# 802.3dj D1.2

## Comment Resolution

### Optical Track

# Introduction

# Comment #139

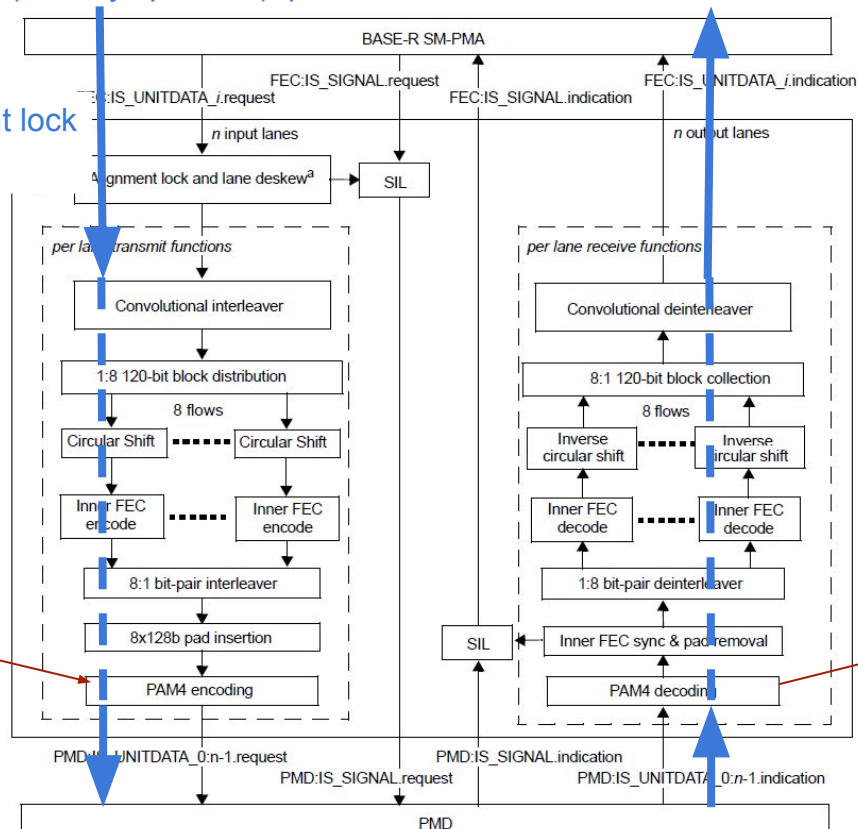
Test pattern checker:  
PRBS31Q?

Consider adding PRBS31Q checker at the Inner FEC Rx path input.

Add PRBS31Q, PRBS13Q, SSPRQ, square wave pattern generators at the output of the Inner FEC transmit path.

Add pattern 8, which is PRBS31 generated at PMA, processed by the Inner FEC transmit path, except bypassing alignment lock and deskew in the Inner FEC transmit path.

Assuming that the PRBS31 generator and PRBS31 checker (with block error ratio counters) are defined in the PMA. See comment #135.
